Safety Recall

N242441390 Seatbelt Retractor May Lock

Revision: 01

Revision Description: This bulletin is being revised to update the inspection steps in the service procedure. Please discard all previous copies of bulletin N242441390.

6682024

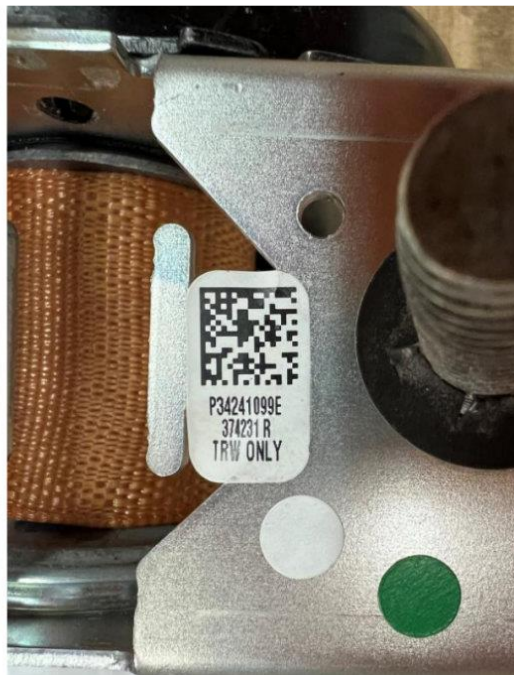
1. Inspect the NEW Seatbelt Retractor labels located on the bottom of the Seatbelt Retractor.

- If the 4th and 5th digits are "23" AND the 1st and 2nd digits range between "35"-"52", The part is BAD and MUST be scrapped. DO NOT INSTALL ON VEHICLE. Reference the Scrap Instructions below. Re-order a replacement Seatbelt Retractor and repeat inspection.
- If the 4th and 5th digits are "23" AND the 1st and 2nd digits DO NOT range between "35"-"52" proceed to Step 2.

Important: DO NOT install the replacement Seatbelt Retractor(s) if they fail one or both inspections below.

6682025

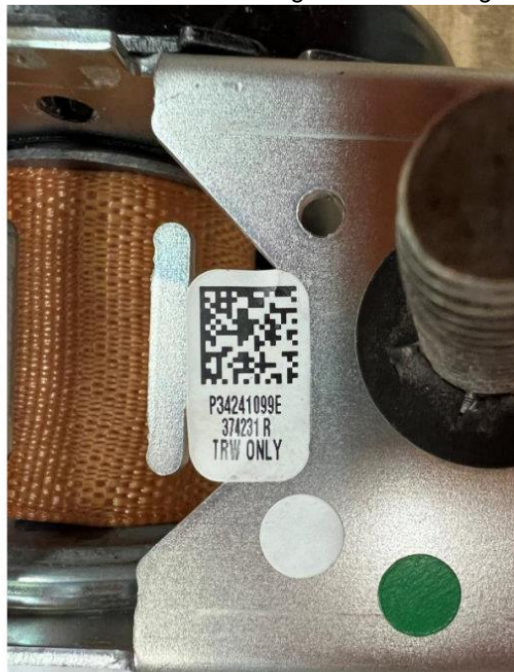
2. Continue to inspect the NEW Seatbelt Retractor labels located on the bottom of them retractor.
 - If the 4th and 5th digits are “24” AND the 1st and 2nd digits are “01”, The part is BAD and MUST be scrapped. DO NOT INSTALL ON VEHICLE. Reference the Scrap Instructions below. Re-order a replacement Seatbelt Retractor and repeat inspection.
 - If the 4th and 5th digits are “24” AND the 1st and 2nd digits are NOT “01” proceed to Step 3.
3. Replace BOTH the LH and RH Front Seat Belt Retractor. Refer to *Front Seat Belt Retractor Replacement* in SI. If convertible, refer to *Front Seat Belt Retractor Replacement - Right Side (Convertible)* and *Front Seat Belt Retractor Replacement - Left Side (Convertible)* in SI.
4. Scrap all replacement Seat Belt Retractors that failed inspection steps 1 and/or 2 AND the used Seatbelt Retractors. Refer to the Scrap instructions below.
